**To:** Planning Commission **From:** Land Use Management **Meeting Date:** July 19, 2021 **Report date:** July 13, 2021

# <u>PUBLIC HEARING: Request for CUP for Non-Metallic Mineral Extraction Facility (Herrick Properties, LLP)</u>

Re: Herrick Quarry CUP Request for Additional Information

# **Cherry Grove Quarry Proposed Operations**

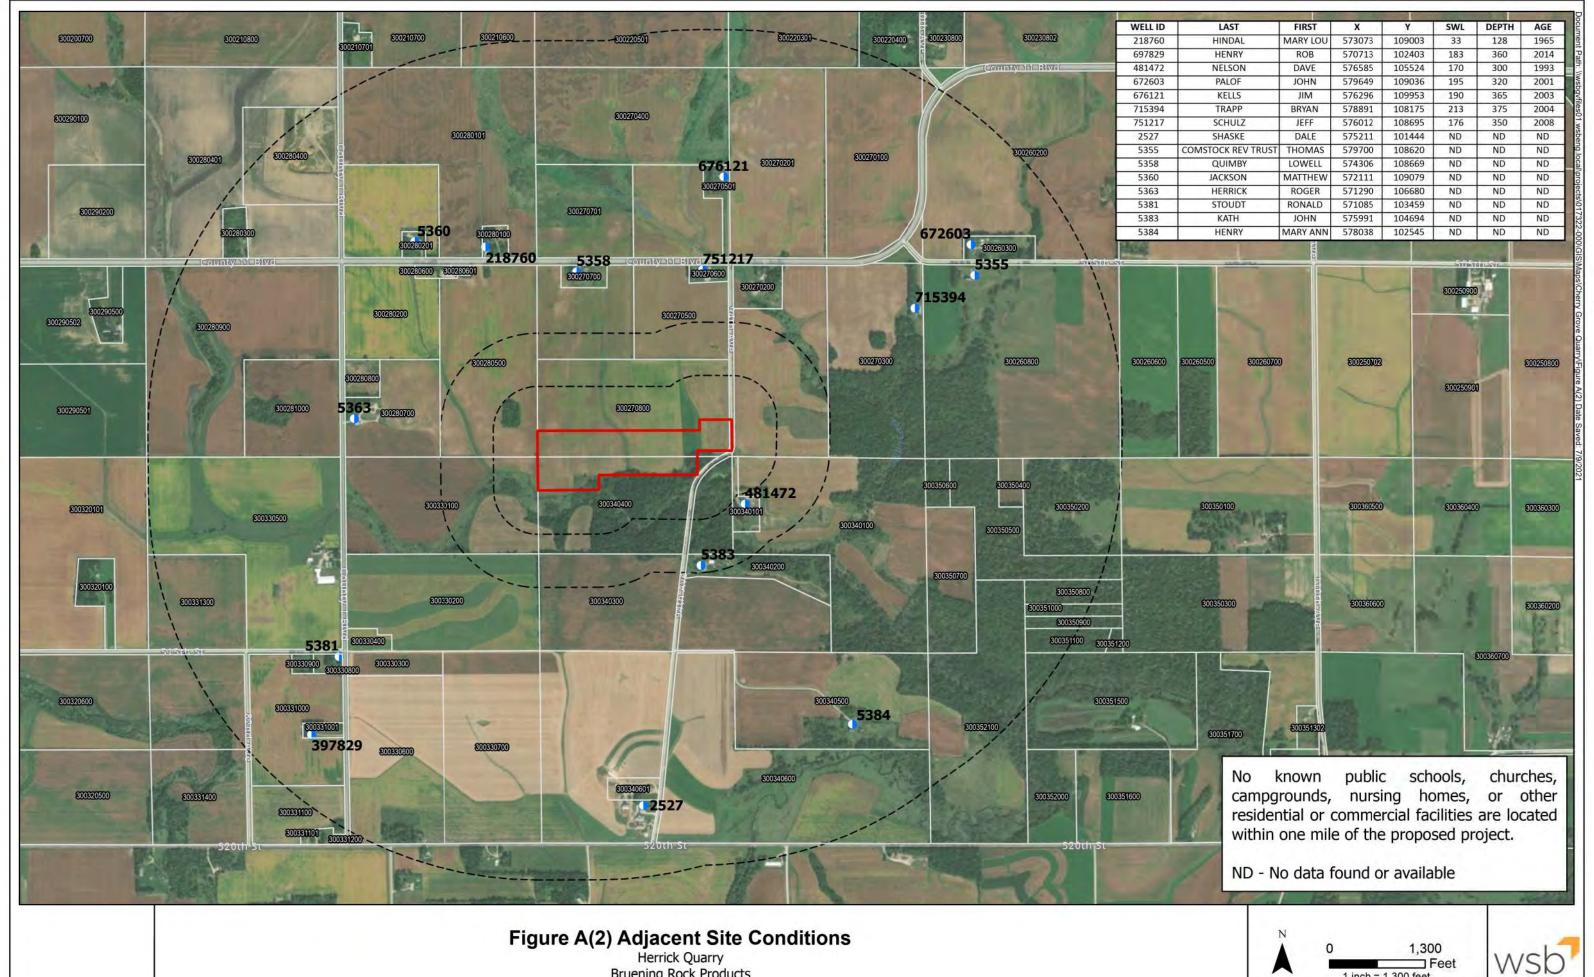
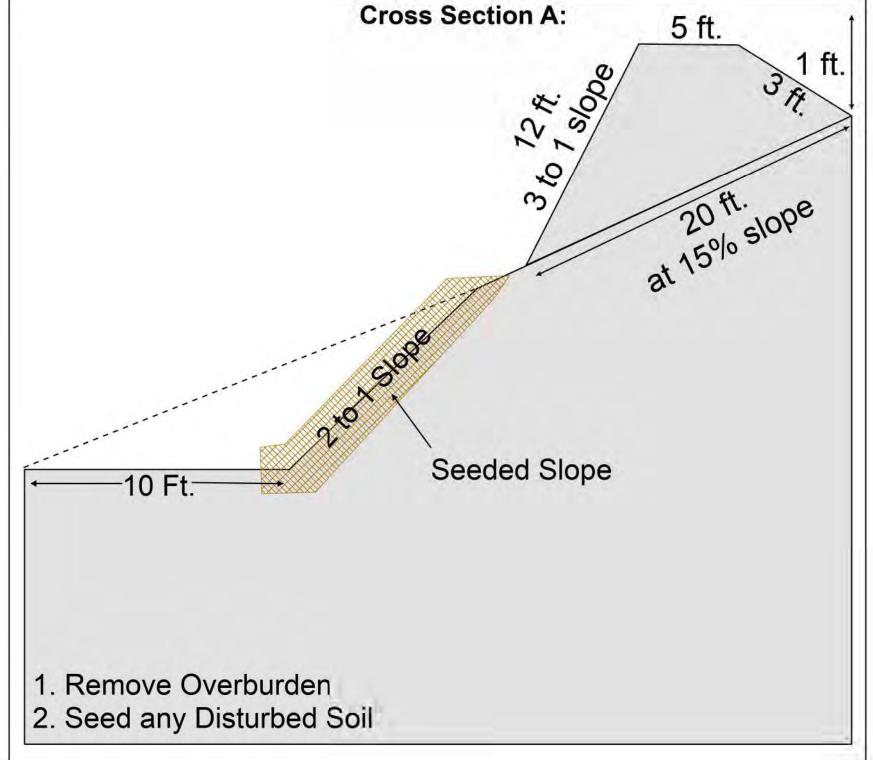
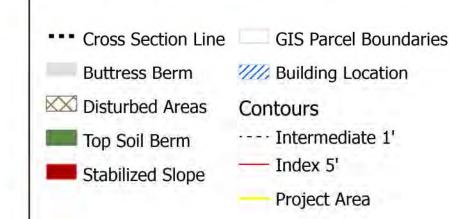
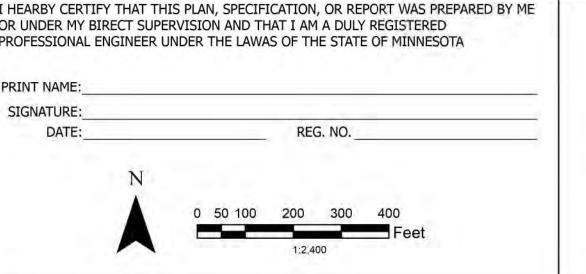
- More detail is needed regarding how the "Grading will be established and extended throughout the life of the quarry to direct storm water flow around the quarry to continue existing drainage patterns." How will the grading be completed, is there a structure being installed to handle the contributing watershed coming from the agricultural field to the edge of the quarry? Designs should be provided to demonstrate the proposed grading plans to ensure it can handle the incoming watershed. Plans should show what would happen if the water enters the quarry and how it will be treated.

- The plan does not show the revision to convert the rehabilitated area to a 3:1 slope as stated in the ordinance. Applicants only stated plans would be revised to a 3:1 slope.

5. The SW portion of the proposed mine will be located within the Shoreland (~115' from the stream edge).

The mining limits have been revised to include a 300ft buffer from the stream south of the project limits. See revised attached figures.

Mining Limits have been revised to ensure the project meets the required 300 ft buffer requirements of the shoreland ordinance.

Mining limits have been revised to meet the 300ft shoreland setback requirements. Dewatering will not be necessary as Bruening Rock Products will mine to elevations above water table. Geotechnical borings identify a perched water table above the first encountered bedrock due to an ash layer. Water table was not encountered within the remaining boring depths as identified in the soil boring logs.

# **Cherry Grove Quarry Reclamation Plan**

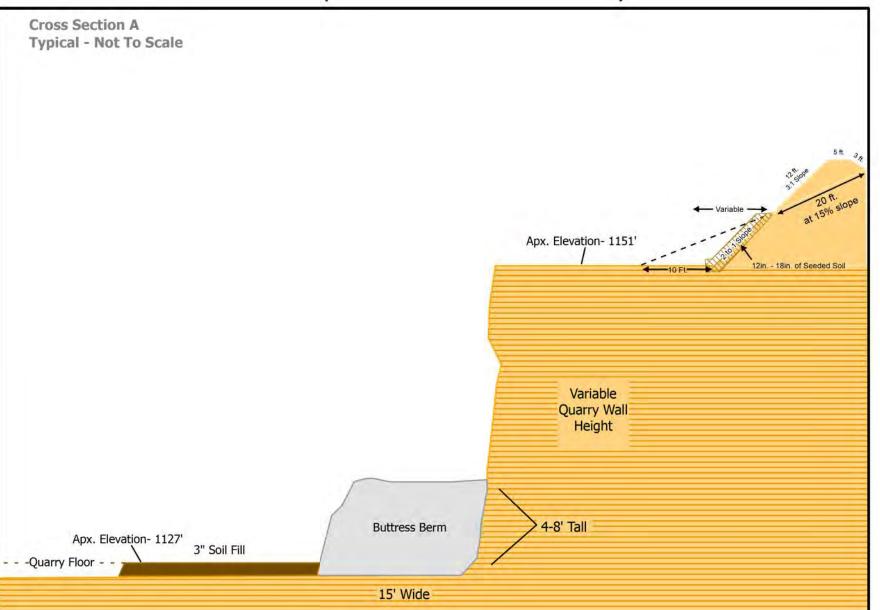
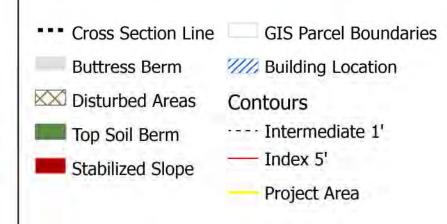
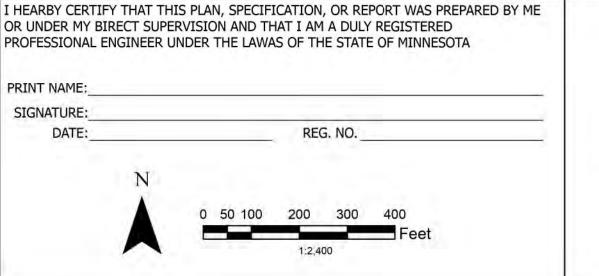
3. The detail provided in the rehab plan does not meet the mining ordinance spec for Land Reclamation on new facilities. Slopes must be 3:1 or gentler. Same goes with the Soil restoration standards section.

Reclamation plans will be revised to meet the 3:1 slope requirement for the reclamation and restoration standards.
